ADDENDUM

Addendum Number:	01	Dated:	December 3, 2025
Solicitation Number:	MR11973		
Solicitation Title:	Move Dump Station at Bonham State Park		
Due Date/Deadline:	<b>Revised December 12, 2025, at 2:00 PM CT</b>		
Contract Manager:	Anthony Habermann, CTCD, CTCM

PURPOSE OF ADDENDUM: NOTIFICATION OF CHANGES AND ANSWERS/CLARIFICATIONS TO QUESTIONS SUBMITTED

BONHAM STATE PARK  
MOVE DUMP STATION  
PROJECT NUMBER: MR11973

**SHEET NUMBER**  
**G1**  
OF  
MR11973

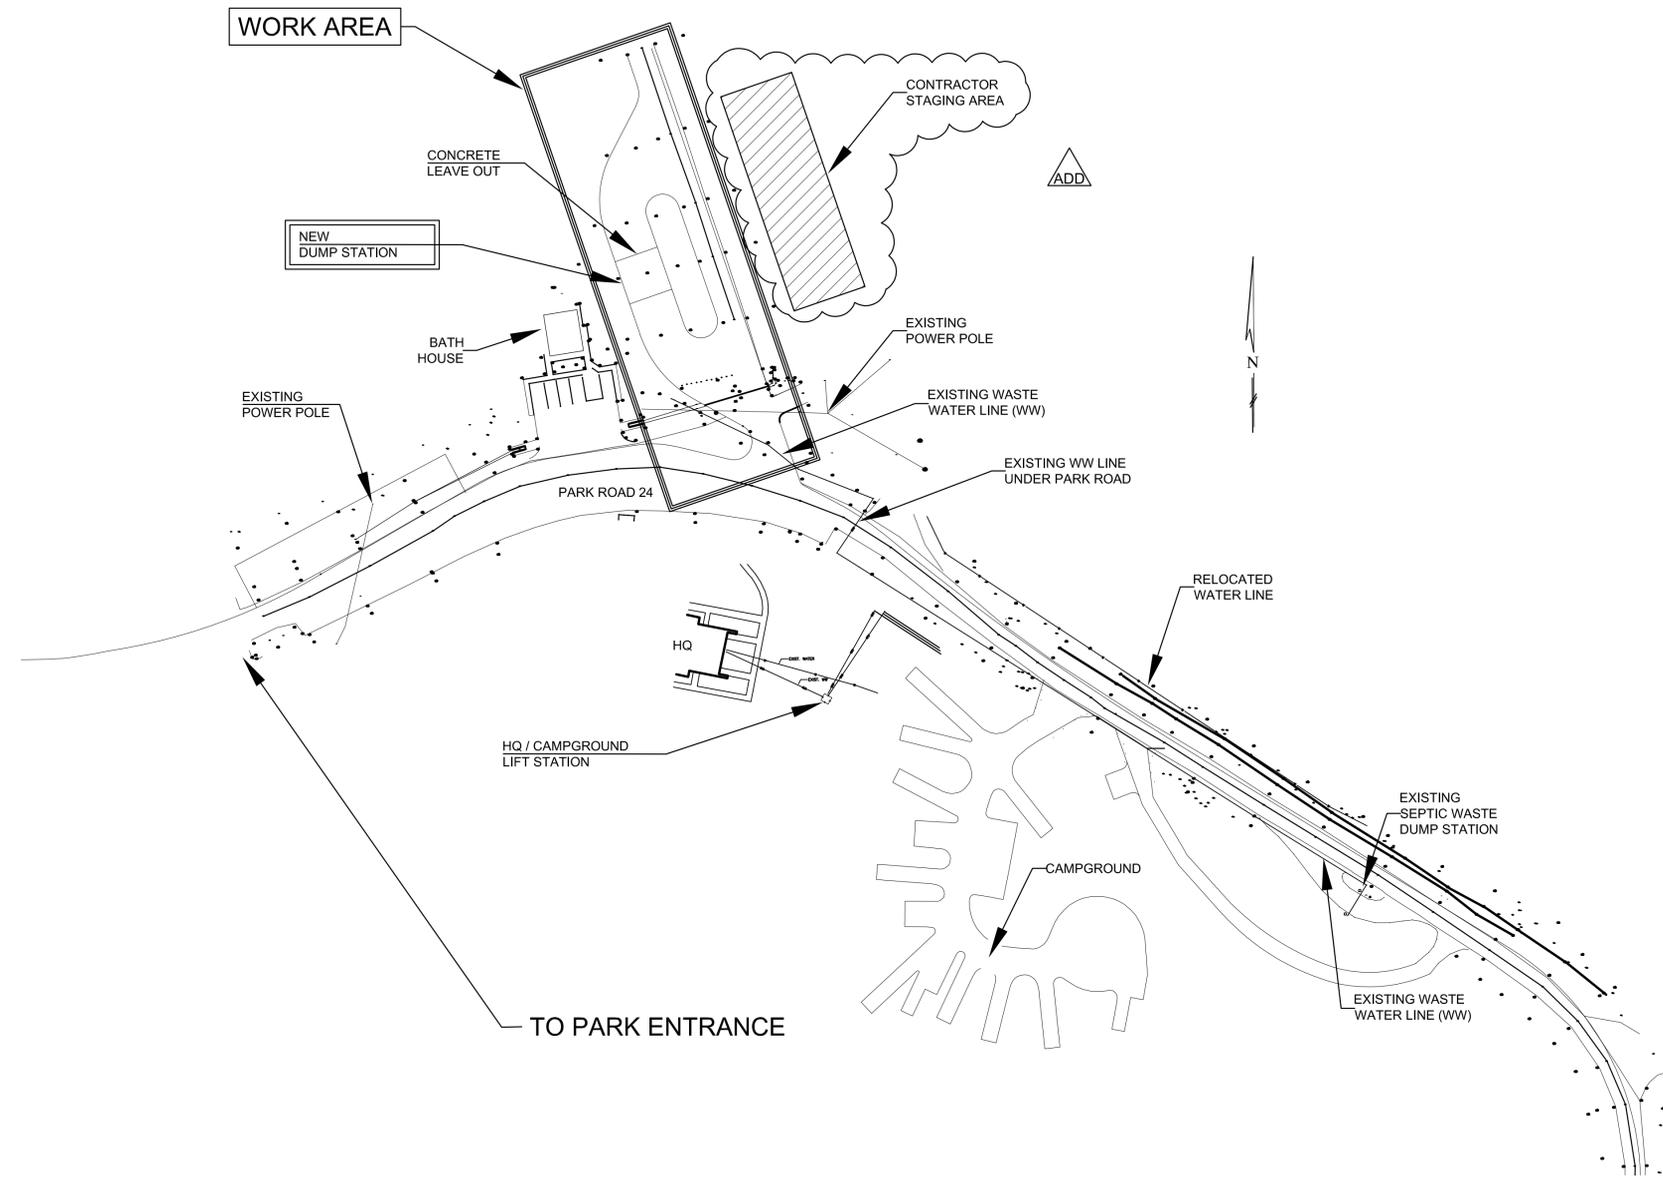
Q8: The existing dump station shall be removed or abandoned in place. Please clarify if the existing dump station is to be removed or abandoned in place. Reference G1 note 5 on the drawing.

Q9: Is there a designated laydown/ materials storage area ?

**A8: THE EXISTING DUMP STATION SHALL BE ABANDONED IN PLACE. SHEET G1 NOTES HAVE BEEN UPDATED.**

**A9: THE DESIGNATED LAYDOWN/MATERIAL STORAGE AREA HAS BEEN UPDATED AND IS NOTED ON SHEET G1.**

NEW DUMP STATION LAYOUT PLAN

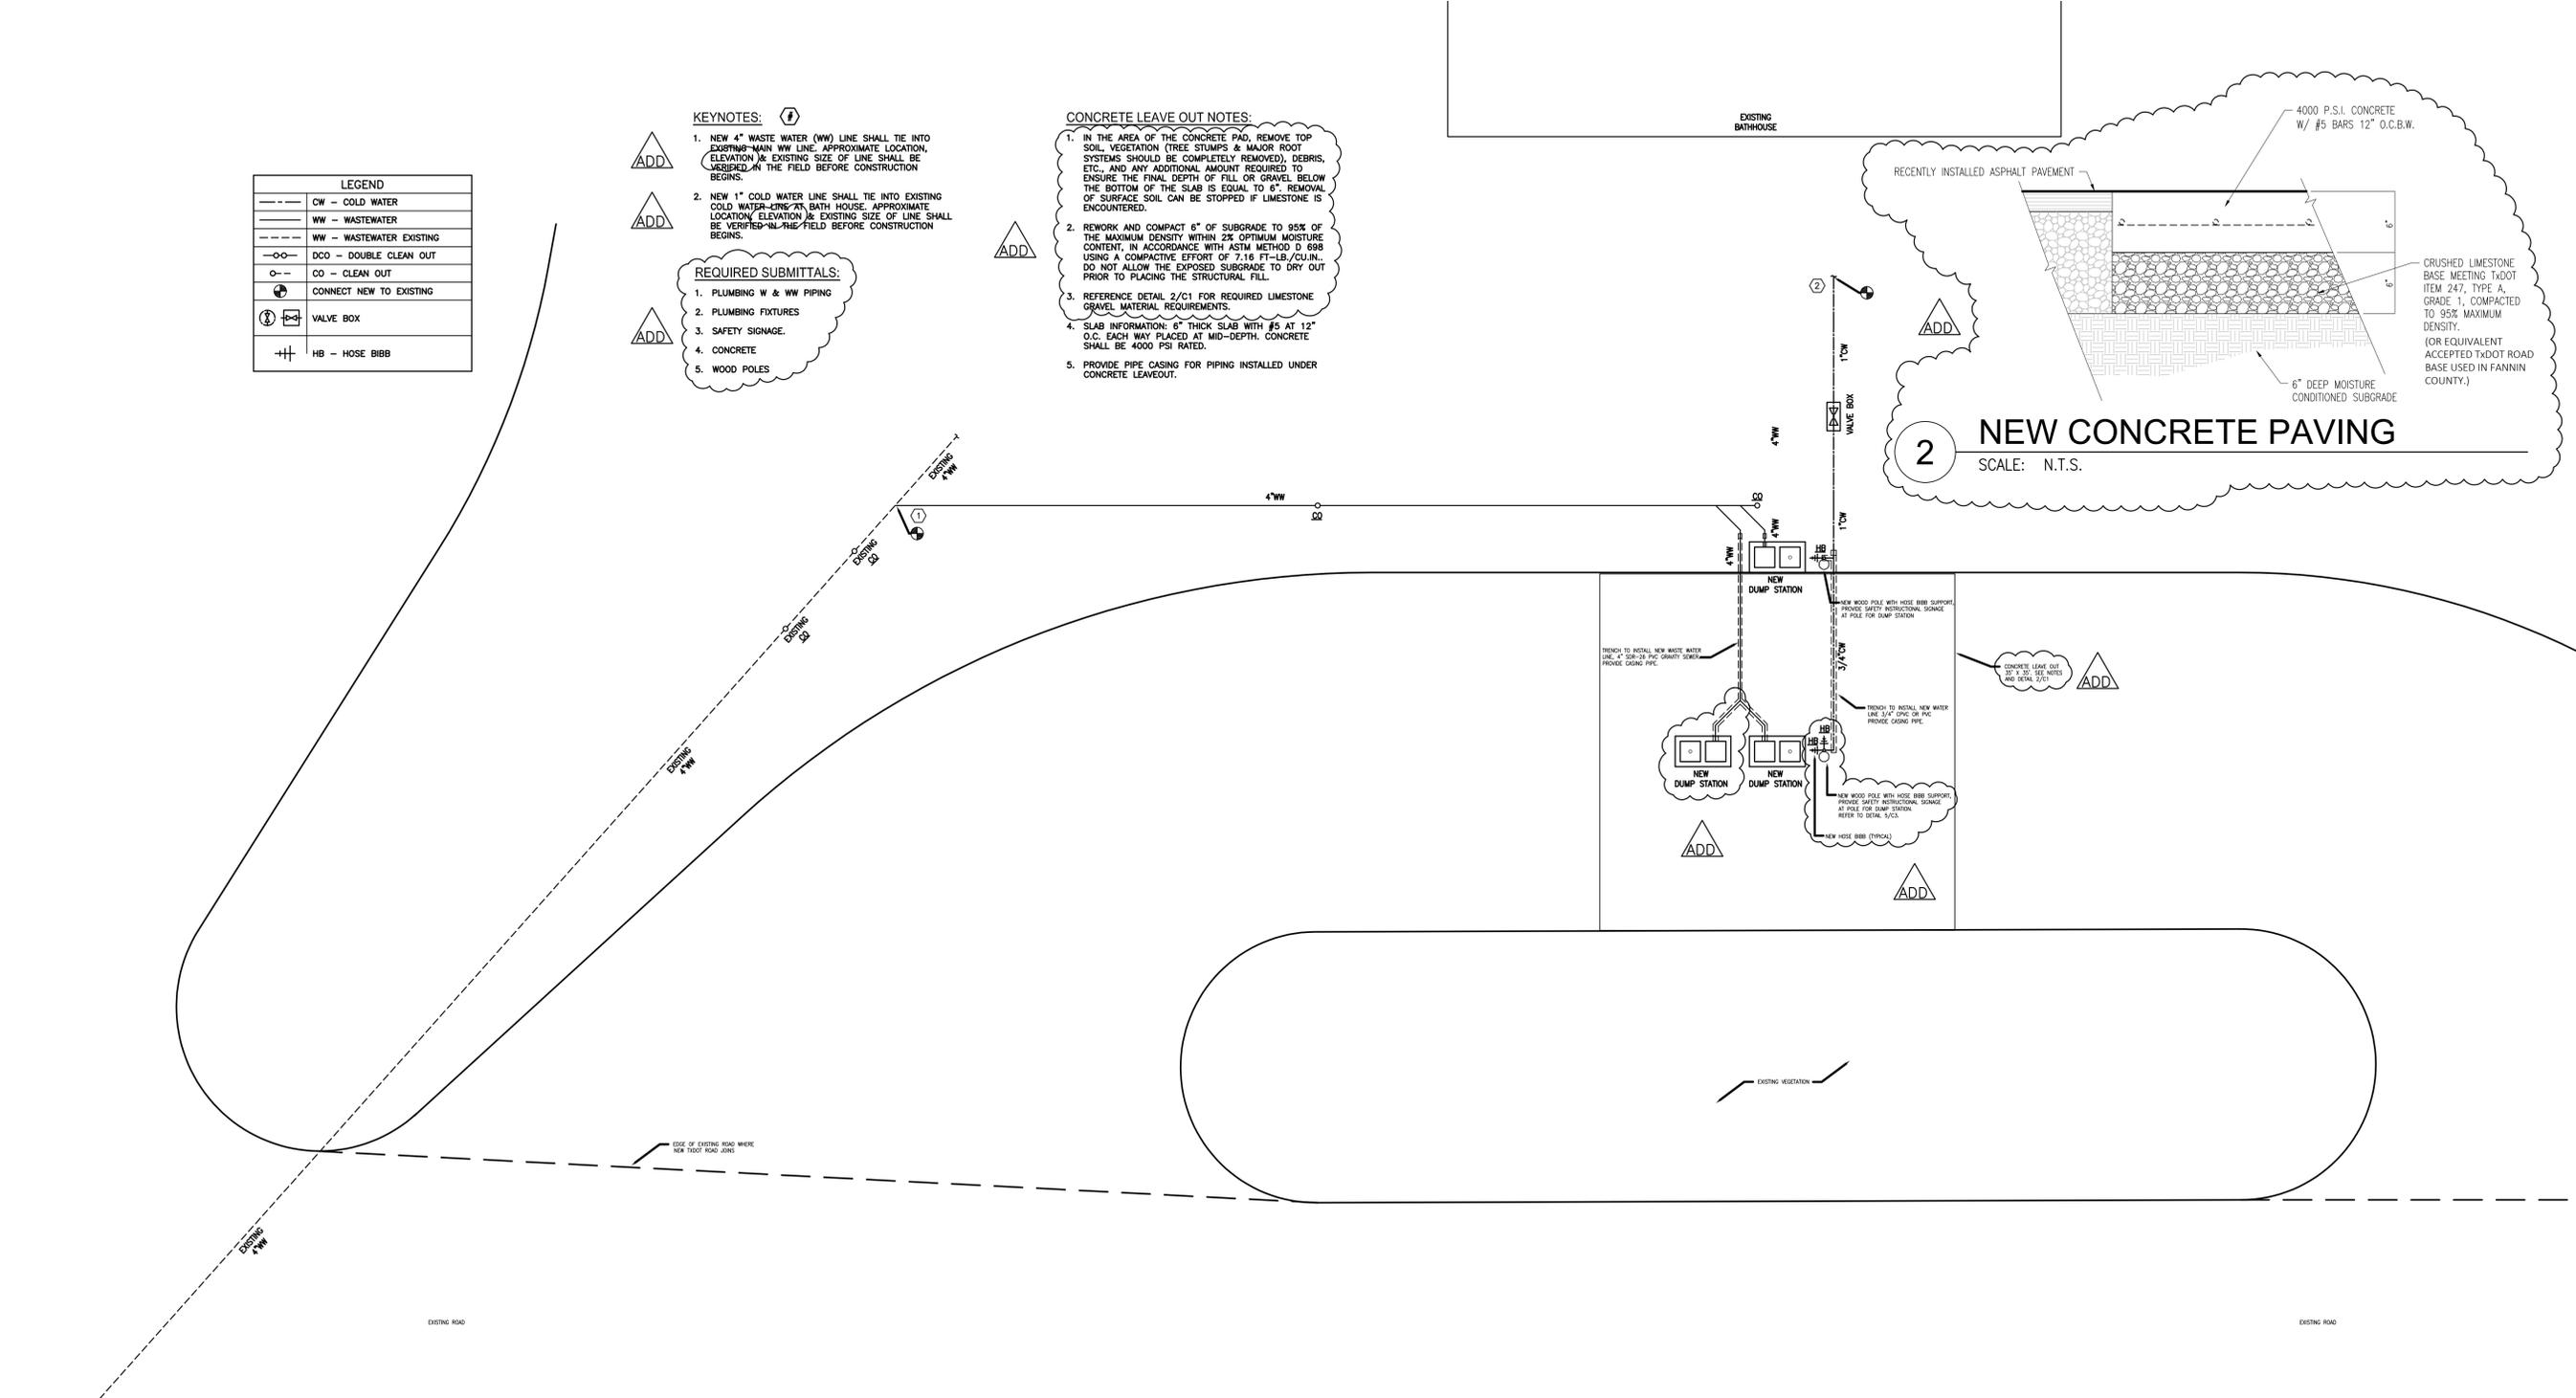
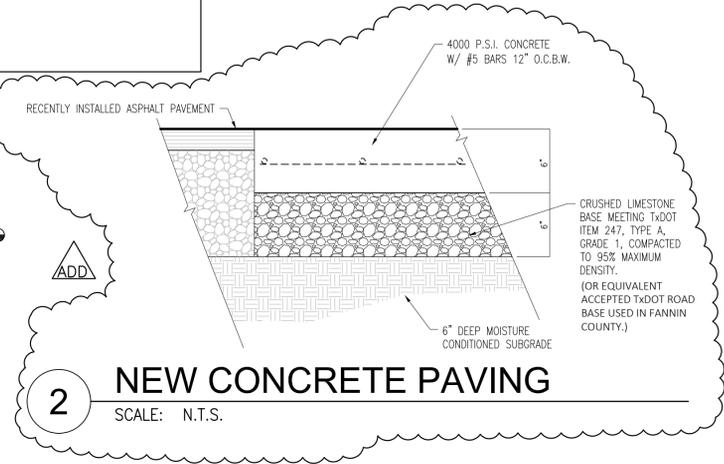
**The following revision was included on sheet C1: ADDED AN ADDITIONAL WASTE DROP AT THE CENTER DUMP STATION.**

Q1: Is there a specific size gravel required under the concrete paving area. A specification requirement was not provided.

Q5: Please advise if there are any elevations associated with the 4" wastewater tie-in in relation to the new drain at the new dump station?

**A1: REFER TO SHEET C1 FOR UPDATED SUBGRADE REQUIREMENTS AT THE CONCRETE PAVEMENT AREA.**

**A5: EXISTING WATER AND WASTEWATER LINE ELEVATIONS ARE UNKNOWN AND SHALL BE FIELD VERIFIED. KEYNOTES ON SHEET C1 HAVE BEEN UPDATED.**

2 SECTION - EXISTING LIFT STATION  
N.T.S.

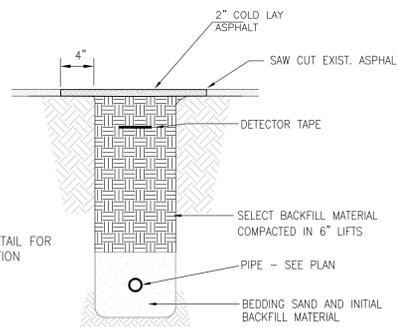
Q3: Detail 2 on Sheet C3 indicates new duplex 2 HP submersible effluent pumps, however there is no specification. Please advise. Also note, site staff indicated that new pumps were not required as this lift station is only eight (8) months old.

Q4: Please advise if new stainless steel lifting chain is required at existing lift station.

**A3: EXISTING LIFT STATION TO REMAIN, DETAIL 2/C3 HAS BEEN UPDATED.**

**A4: EXISTING STAINLESS STEEL LIFTING CHAIN TO REMAIN, DETAIL 2/C3 HAS BEEN UPDATED.**
